ALERT SERVICE BULLETIN

206-11-127

**MODEL AFFECTED:** 206A/B (TH-67)

**SUBJECT:** CONTROL BOX ASSEMBLY P/N 206-375-017-101,  
RECALL OF.

Figure 1. Control Box Assembly Location

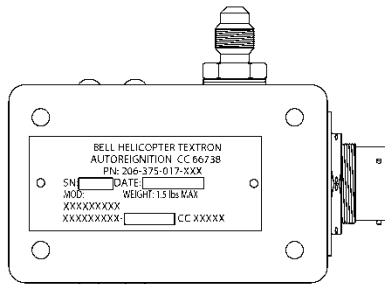
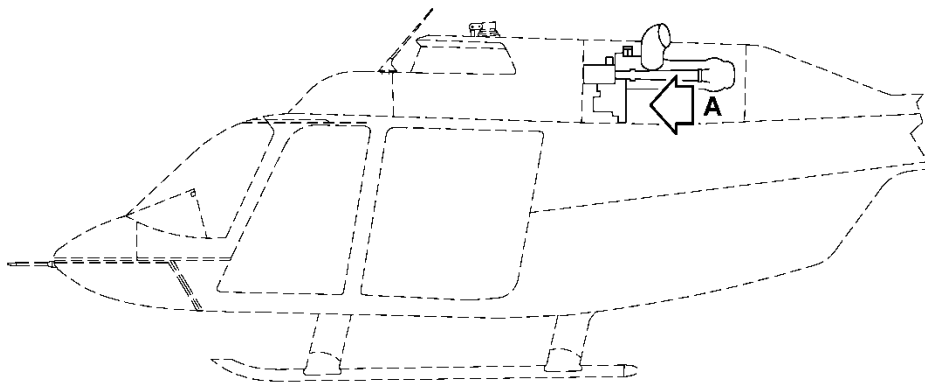
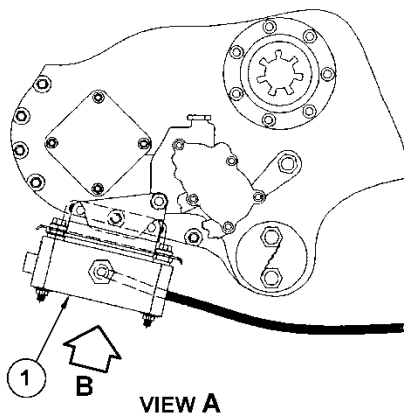
1. Prepare helicopter for maintenance.
  - a. Access L/H side of powerplant.
2. Locate control box assembly. Refer to Figure 1 Item 1.
  - a. Verify part number on control box assembly View B. If the part number identified on the unit is P/N 206-375-017-101 (206A/B), then this unit is affected by the intent of this Bulletin. Proceed to step 3.
  - b. If an original Rolls Royce control box assembly P/N 23050521, 23052372, 6877138 or 6877142 is found installed, no further action is required. Proceed to step 5.
3. Install replacement control box assembly P/N 206-375-017-105. Refer to the Installation Instruction BHT-206-SI-92.
4. Test engine auto-relight system for proper functioning. Refer to the Installation Instruction BHT-206-SI-92.
5. Make an entry in helicopter historical service records indicating compliance with this Alert Service Bulletin.
